Report: TAB Report
Function: Test, Adjust, & Balance
Date: 10/23/2025
Completed By: National TAB

PROJECT
10-13-25 QT #0839 MABLETON, GA

Project Issue Information

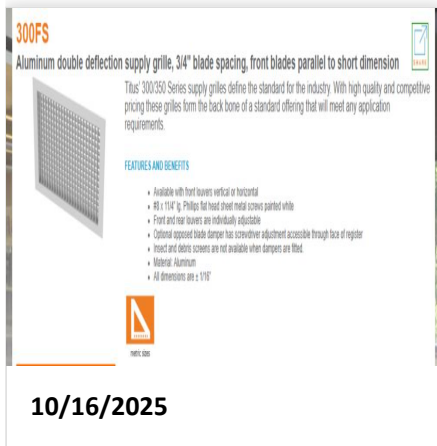
Issue Name : DIFFUSERS ARE THE WRONG TYPE
Description : The installed diffusers in the kitchen are not the correct specified model
Created By : National TAB **Assigned To :** National TAB - Sagar Patel
Status : Closed
Priority : Medium **Asset Tag :**
Originated Date : 10/16/2025 - Ben Searles - National TAB

- **03/05/2026 National TAB - Anthony Taylor**
 - The correct diffusers have now been installed, and the grille have been properly adjusted to distribute airflow evenly.

- Diffusers are still incorrect. Titus diffusers are on back order.

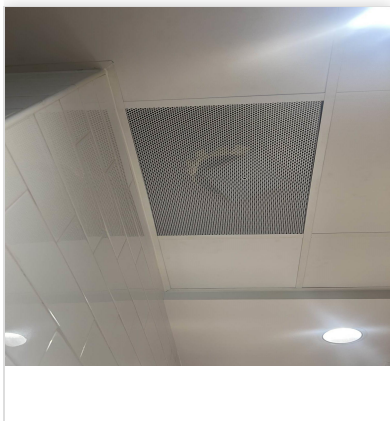
Issue Name : EF-1: MISSING EXHAUST GRILLE
Description : Exhaust grille 1-4 is not installed. Unable to balance EF1 until the return is installed.
Created By : National TAB **Assigned To :** National TAB - Sagar Patel
Status : Open
Priority : Medium **Asset Tag :**
Originated Date : 10/16/2025 - Ben Searles - National TAB

- **03/05/2026 National TAB - Anthony Taylor**
 - Exhaust fan is installed and now balanced to design. The Exhaust grille is not correct.

- **11/12/2025 National TAB - Sagar Patel**
 - Exhaust grill is not correct and ceiling is exposed.

Asset: EF1

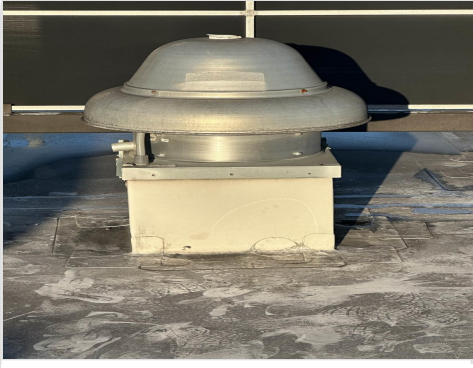
[1] INCORRECT COMBI-OVEN GRILLE INSTALLED. UNABLE TO BALANCE FAN WITH INSTALLED GRILLE. SEE ISSUE.
